*TOLEDO CITY  
PLAN COMMISSION  
REPORT*

*December 1, 2016*

**TOLEDO-LUCAS COUNTY PLAN COMMISSIONS**

# SITE PLAN

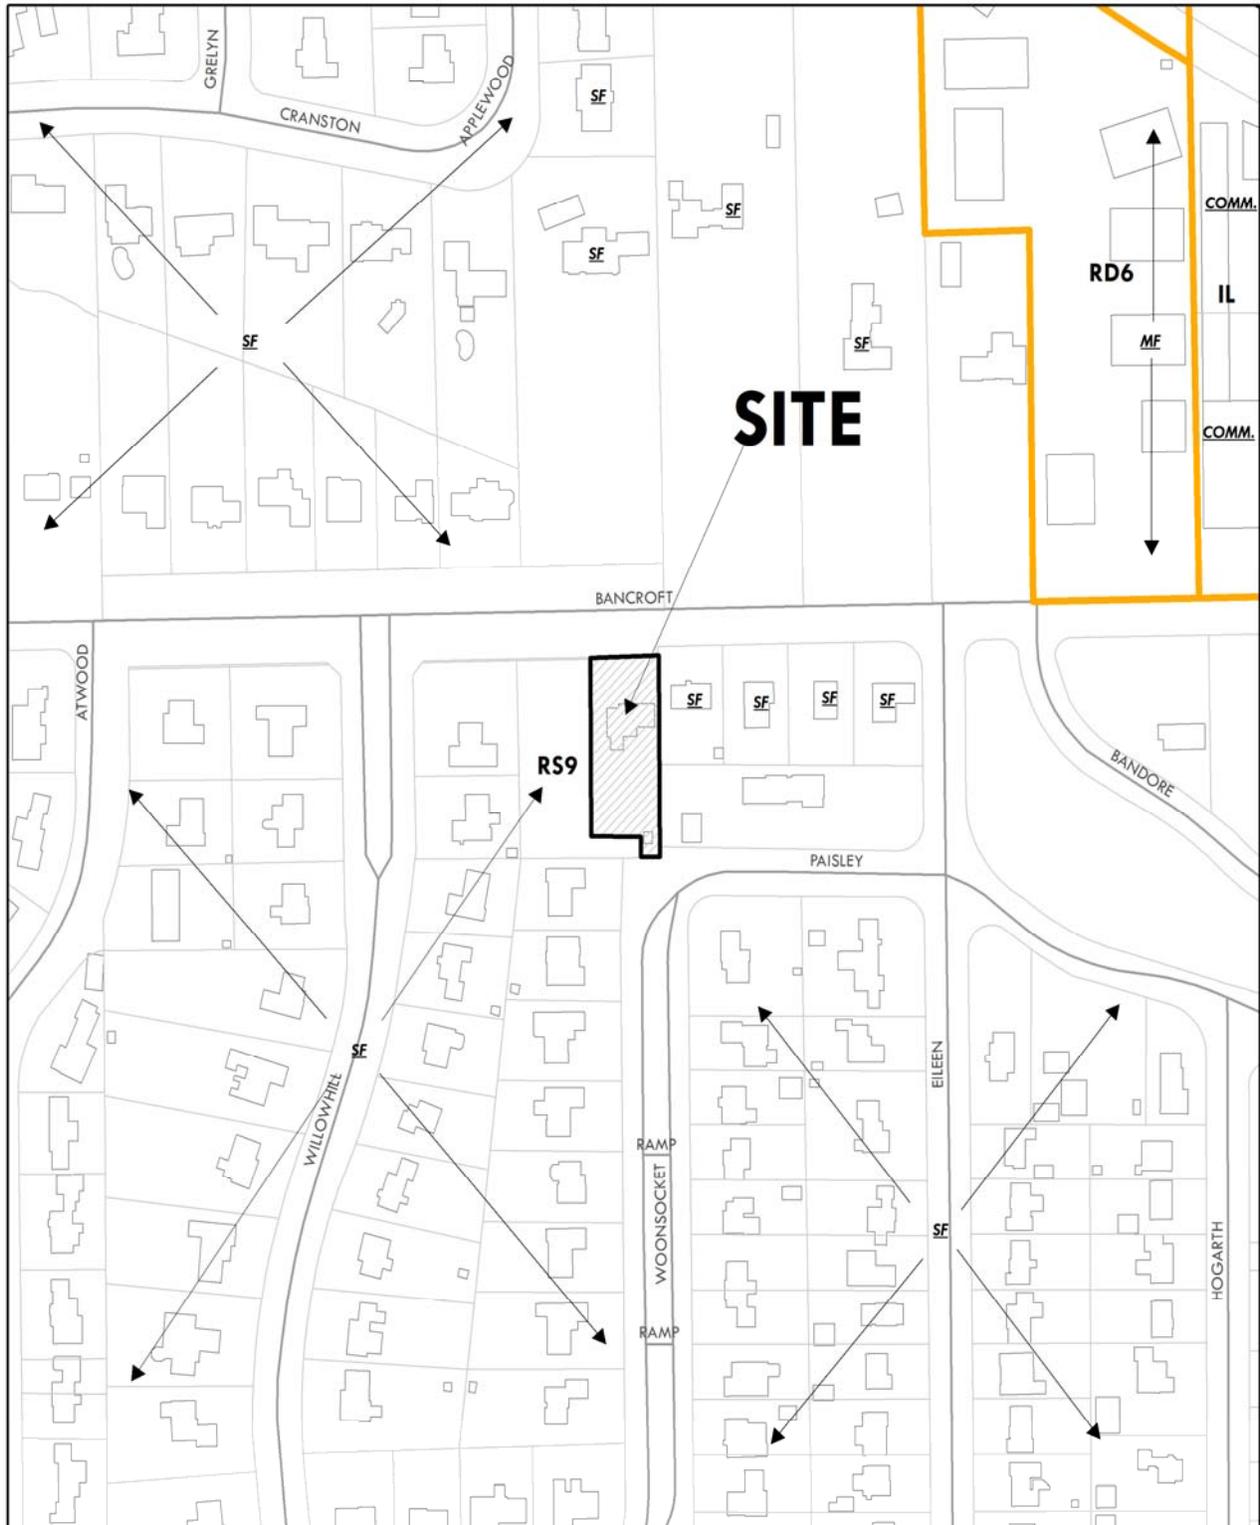
Pursuant to TMC§1107.0304 *Parking, Loading, and Access* – Schedule A, a Type A daycare is required to provide one (1) parking space plus the required parking for the residential dwelling. Single family dwelling units require that two (2) parking spaces be provided for such a land use. Calculations conclude that a total of three (3) parking spaces are required. All parking must be properly marked and meet the dimensional requirements of Toledo Municipal Code 1107. The applicant shall work with the Division of Transportation to ensure the previously mentioned conditions can be met to the satisfaction of the Division.

Sixty (60) square feet of usable outdoor space must be provided for each person in care using the outdoor area at any one time. The site plan offers a ±10,700 square foot outdoor play area that can accommodate more than the maximum number of twelve (12) children allowed. A Type B landscape buffer with solid board on board fence is required to be around the outdoor play area. The site plan depicts a six (6) foot high board on board privacy fence around the play area and is in compliance with the Toledo Municipal Code.

13. In residential zoning districts, a Type A Family Day Care must have building frontage on a major street. **Acceptable as depicted on site plan.** (TMC 1104.0701.C).
14. Group Living facilities, Type A Day Care Home, and Nonresidential Drug and Alcohol Centers that subject to this spacing requirement Section in the Use Table of Sec. 1104.0100, must be at least 500 feet from a site with any other Group Living facilities, Type A Day Care Home, and Nonresidential Drug and Alcohol Center that is subject to this spacing requirement. (TMC 1104.1001).

17. A Type B landscape buffer or fence shall be placed around the outdoor play area. **Acceptable as depicted on site plan.**
18. Off-street parking and loading spaces, parking lots, maneuvering areas, aisles and driveways must be surfaced with concrete, bituminous asphalt, or other dust-free material other than gravel or loose fill, and be graded to drain all surface water towards the interior of the parking lot.

- b. The location and type of any proposed fencing. The fencing is subject to the approval of the Director of the City of Toledo Plan Commission **(acceptable as depicted on the site plan);**

# LANDSCAPE PLAN

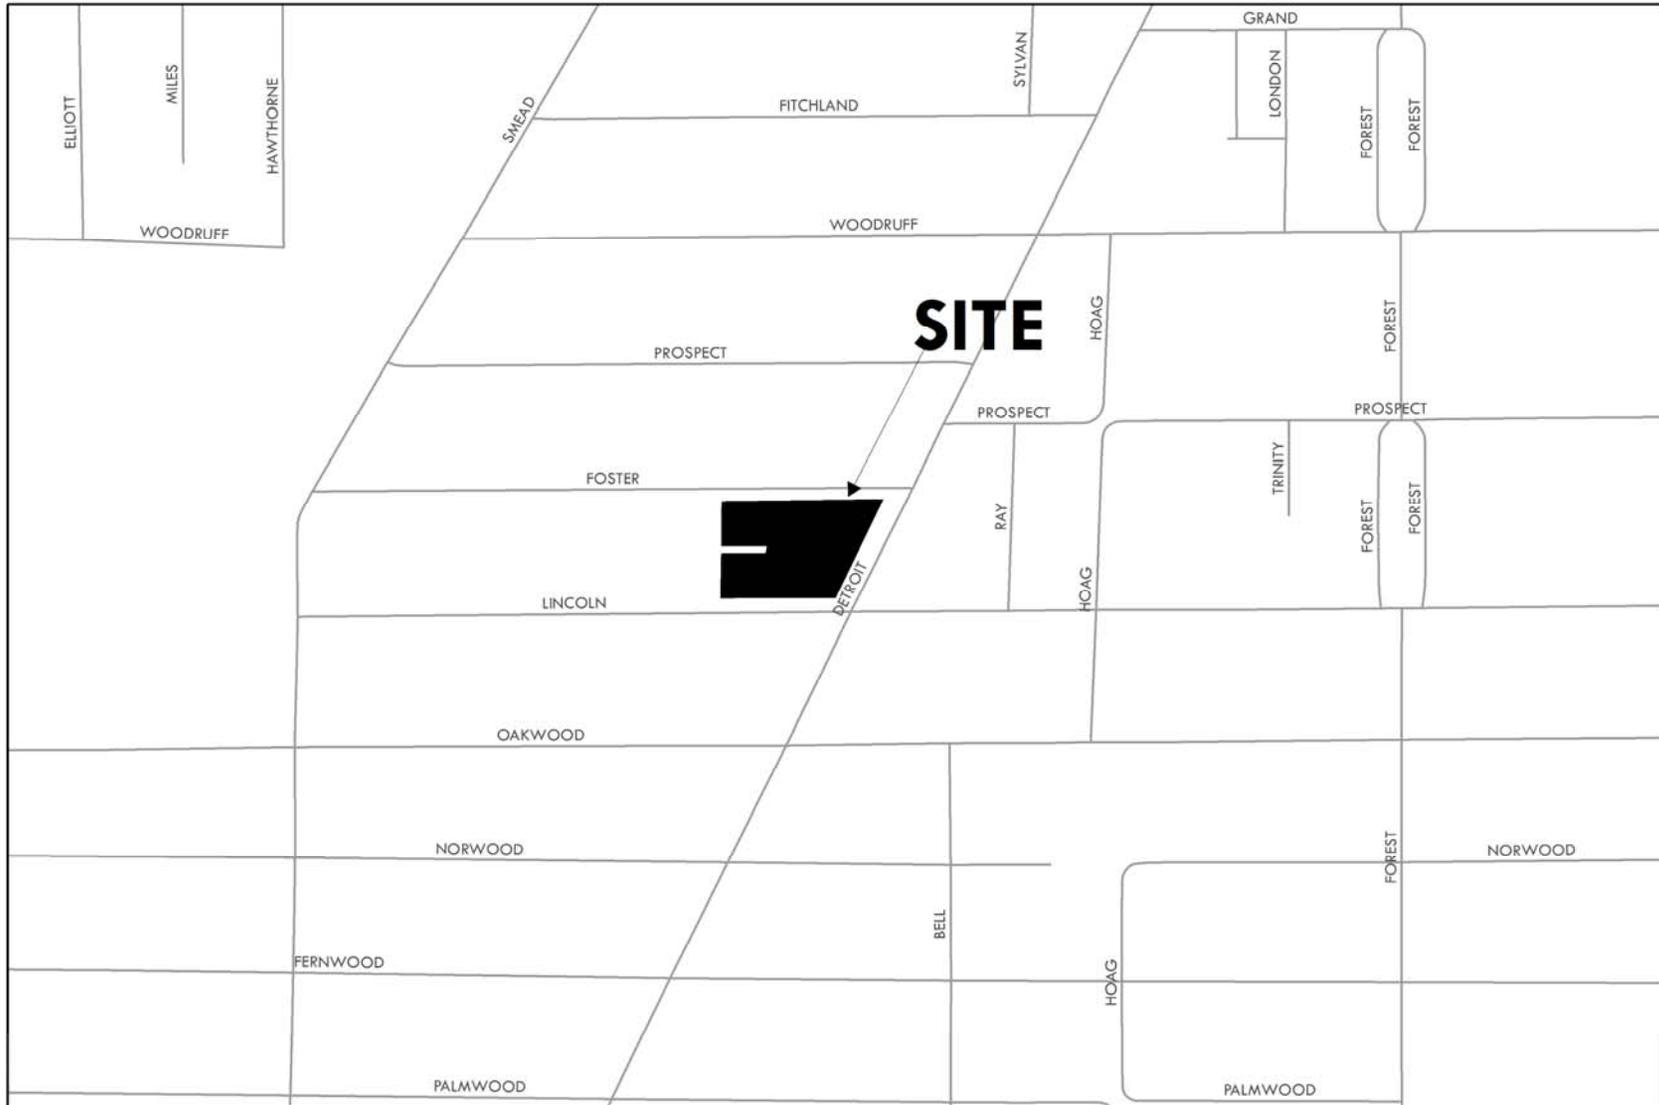
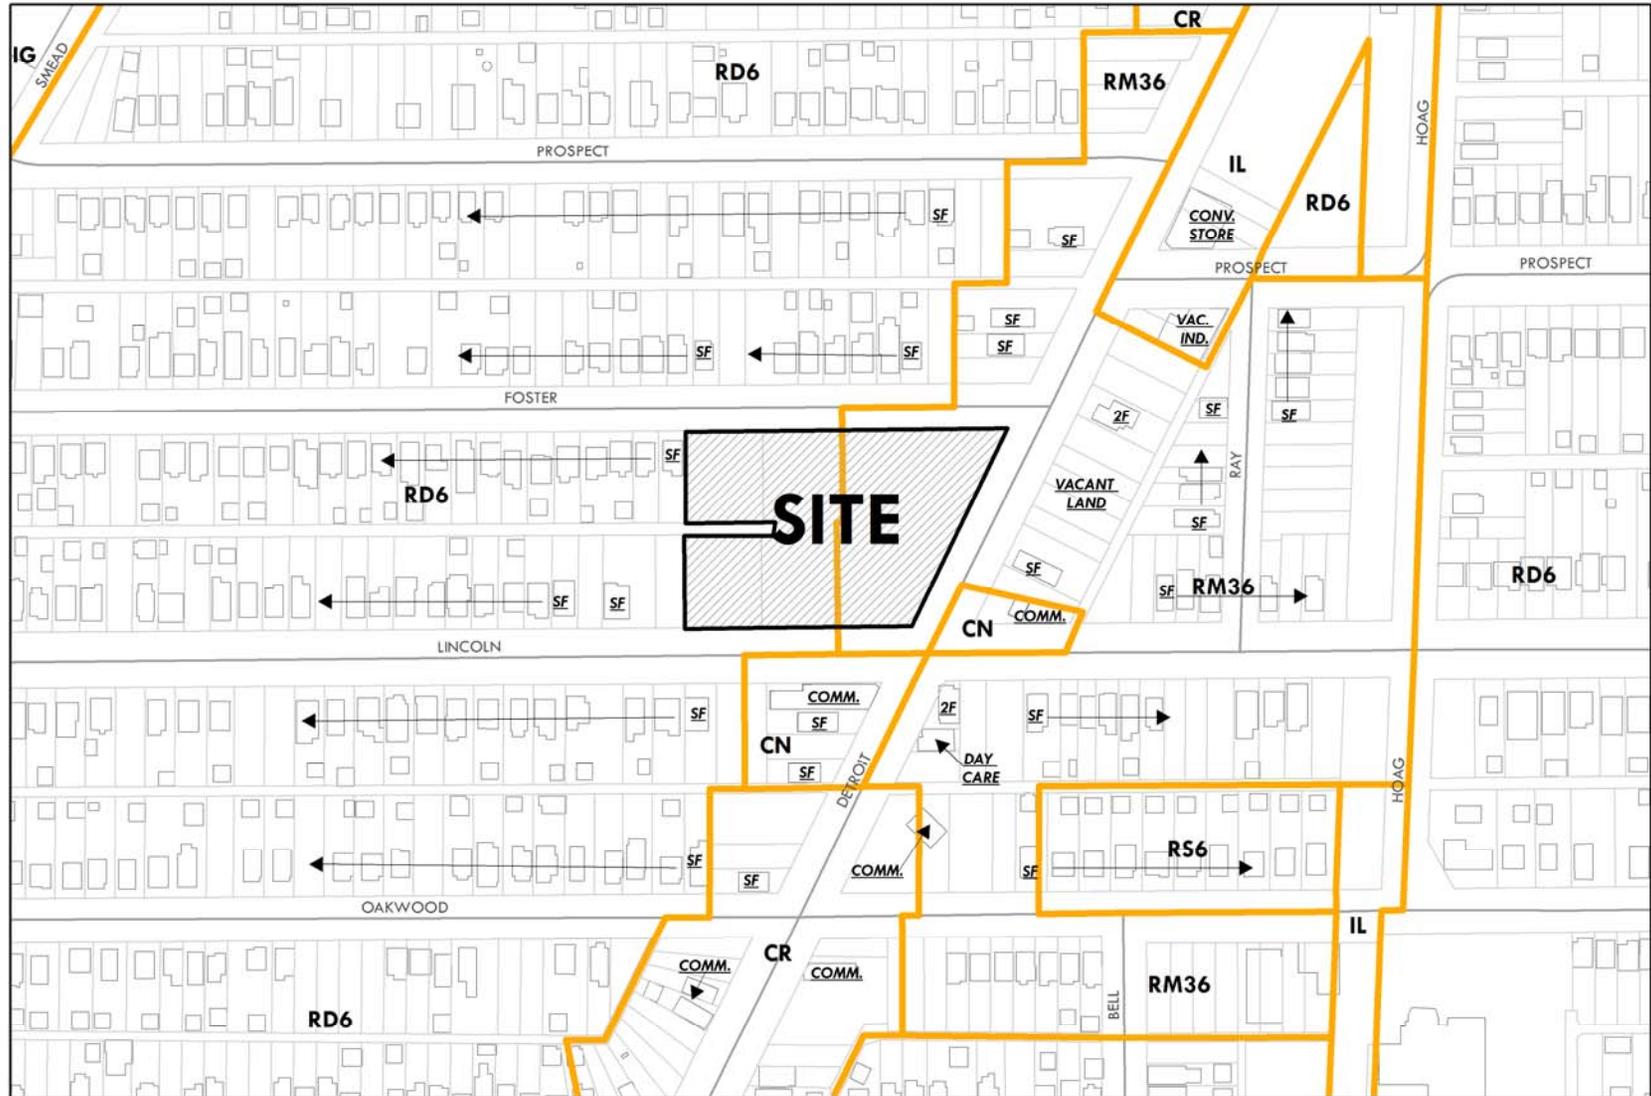
The apartment provides thirty three (33) spaces and is required to provide one hundred seventeen (117) spaces.

Disapprove a waiver to reduce the required one hundred seventeen (117) spaces for both the apartment and job training facility to thirty three (33) parking spaces.
